ENVIRONMENTAL REVIEW TEAM REPORT
ON
BEAR SWAMP ROAD SUBDIVISION
EAST HAMPTON, CONNECTICUT
JULY, 1976

ENVIRONMENTAL REVIEW TEAM REPORT
ON
BEAR SWAMP ROAD SUBDIVISION
EAST HAMPTON, CONNECTICUT

The Eastern Connecticut Environmental Review Team was asked to review approximately 177 acres of land for which a single-family home subdivision is proposed. The site is located east of Pocotopaug Lake and Route 66, and the eastern site boundary follows a portion of the East Hampton/Marlborough town line.

TOPOGRAPHY AND SURFICIAL GEOLOGY

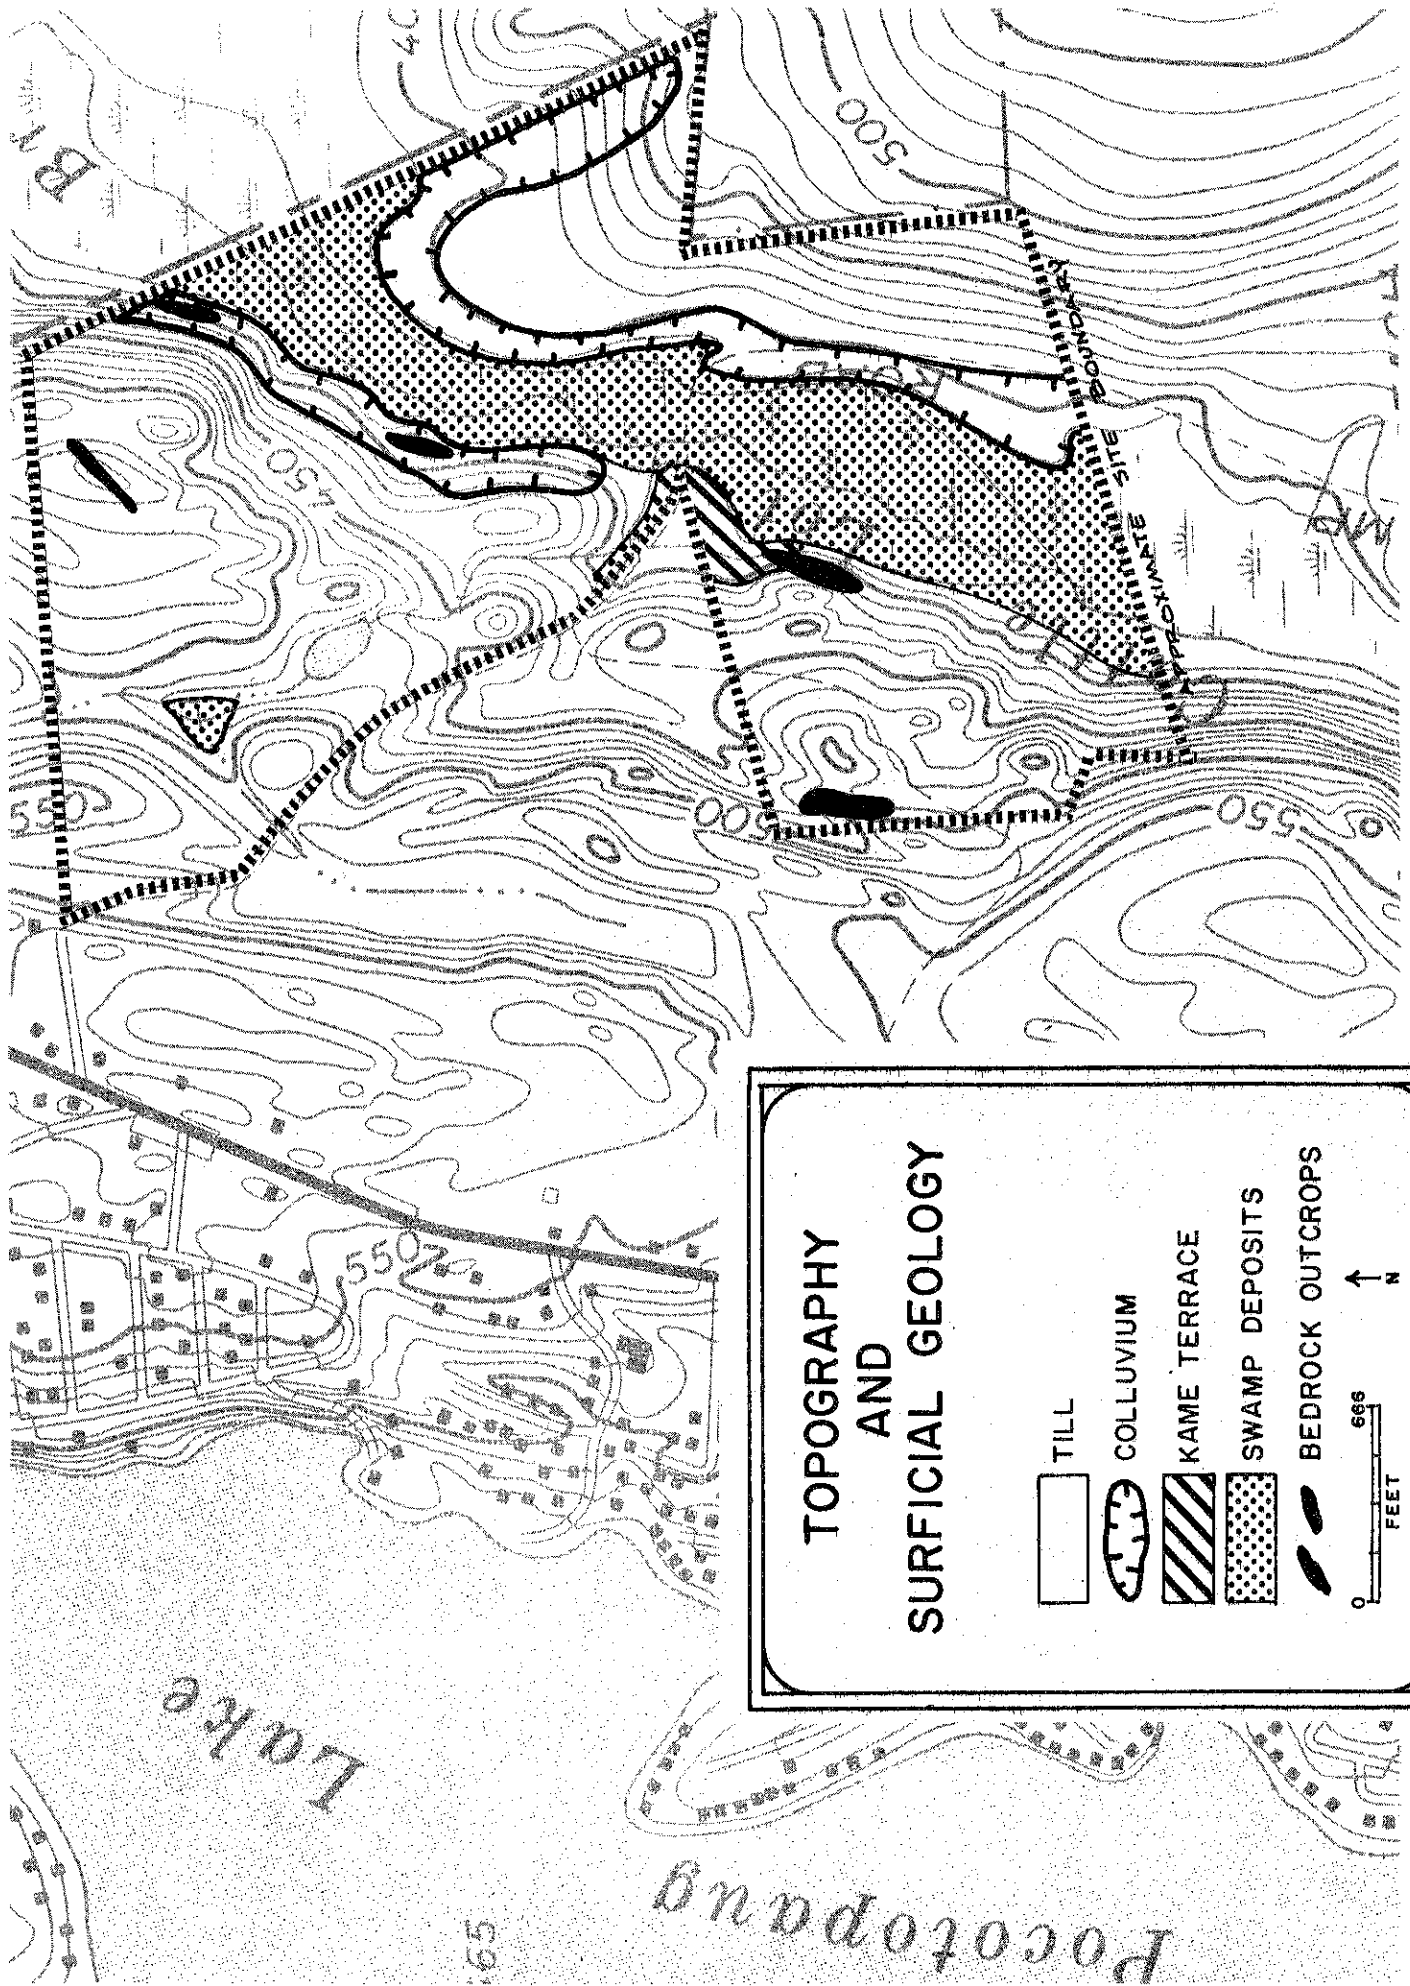
As indicated on the Topography and Surficial Geology Map, there are numerous outcrops located on the west side of Cattle Lot Brook. This area is extremely shallow to bedrock. The map only indicates areas of large outcroppings, many smaller ones were located during the field review. Although the shallow bedrock surface make excellent bases for foundations, they do create problems in design of subsurface sewage disposal and in the placement of onsite water supply wells. Possible further investigation may be needed when designing in shallow bedrock areas.

SOIL MAP

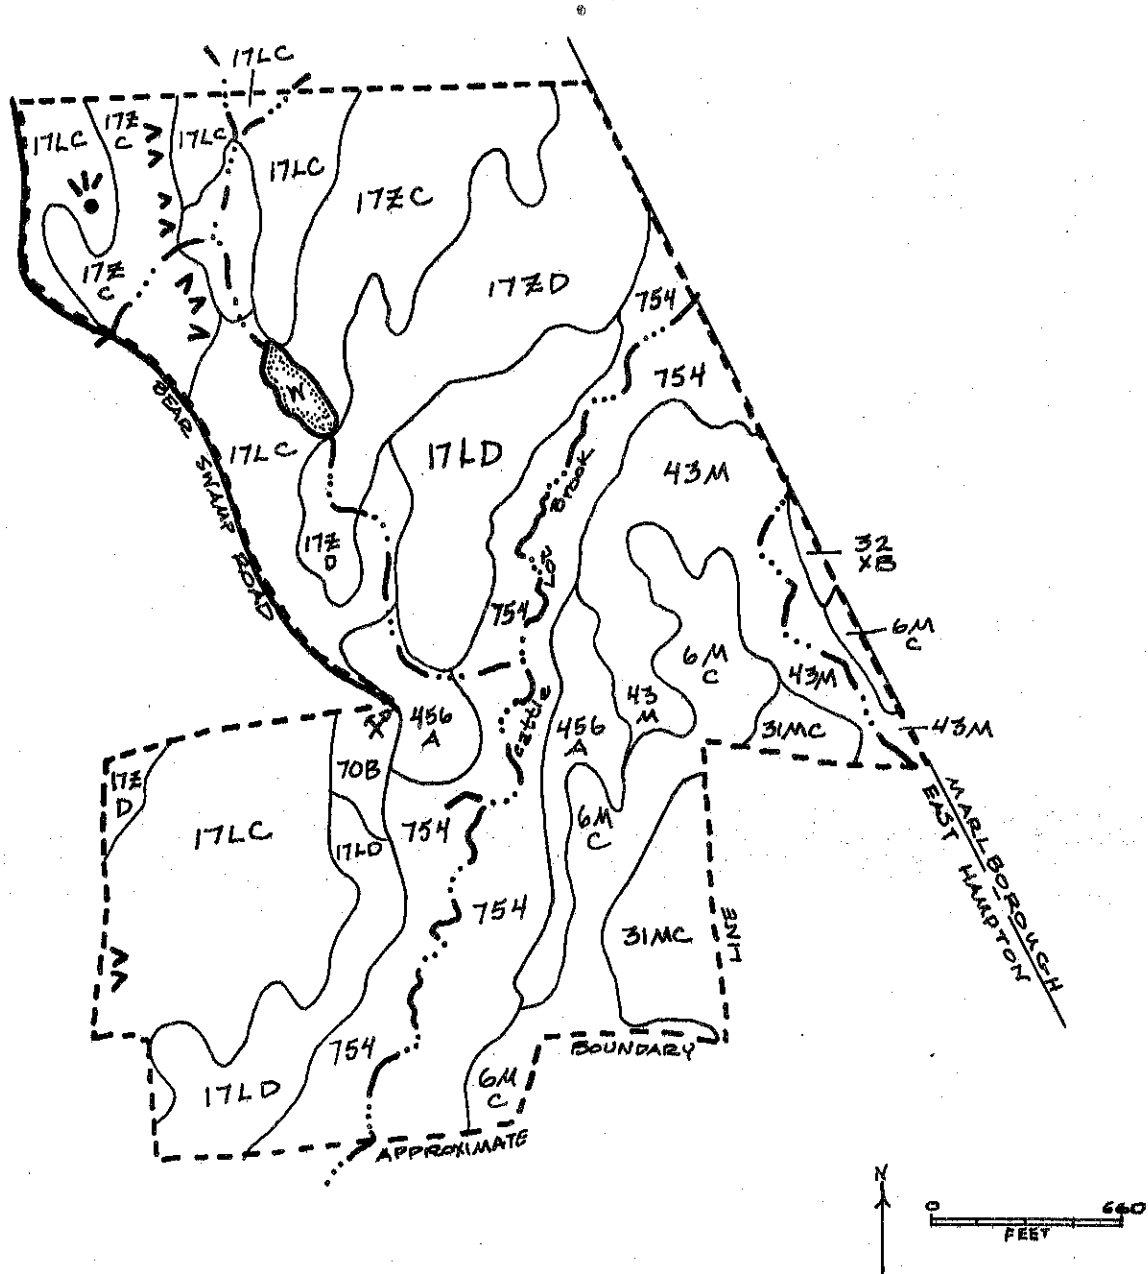
A detailed soil map of the site is given in the Appendix of this report. As the soil map is an enlargement from the original 1,320'/inch to 660'/inch scale, the soil boundary lines shown should not be viewed as absolute boundaries but rather as guidelines to the distribution of soil types on the property. The soils map, along with the SPECIAL SOILS REPORT, Middlesex County (USDA, SCS, 1975), can serve as an educational tool regarding the identification and interpretation of soils.
